FIG. 2K

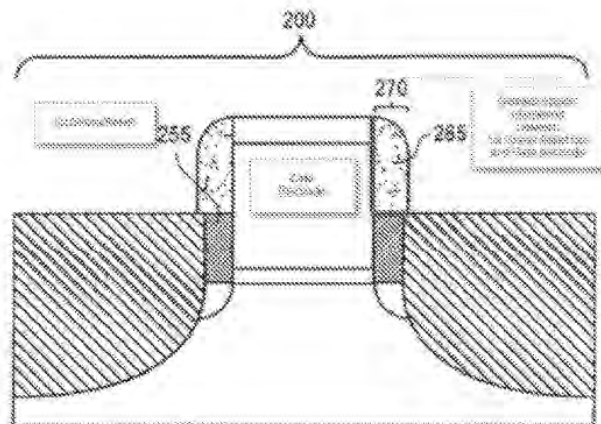
31. As it is shown in FIG. 2K, *the first stress-relief film(255) is formed on the side surface of the first gate electrode(255) with the first sidewall spacer(265) interposed therebetween i.e. the right triangle sides of the first sidewall spacer(265)is bordering with the first gate electrode(255) and the first stress-relief film(255). The claim language does not specify whether it can or cannot be* in direct contact with a side surface of the gate electrode(202).

FIG. 2K – Illustration of the First Sidewall Spacer(265) interposed between First Stress Relief film(255) and Gate Electrode(202)

More specifically, it is asserted that although the alleged first stress-relief film 255 of Sell is in direct contact with the first gate electrode 202, the first sidewall spacer 265 is also disposed between the first stress-relief film 255 and the first gate electrode 202. As noted in the Response to the Arguments section, it appears to be asserted that the upper surface of the first-stress relief film 255 is separated from an upper side surface of the first gate electrode 202 by the first sidewall spacer 265.

In response to the foregoing, Applicants have amended claim 1 to expressly state that ***the first stress-relief film is not in direct contact with the side surface of the first gate electrode.*** Clearly, Sell does not disclose or suggest this element of amended claim 1. As noted above, and clearly shown in the figures of Sell, the asserted first stress-relief film 255 of Sell **is in direct** contact with a side surface of the gate electrode 202.
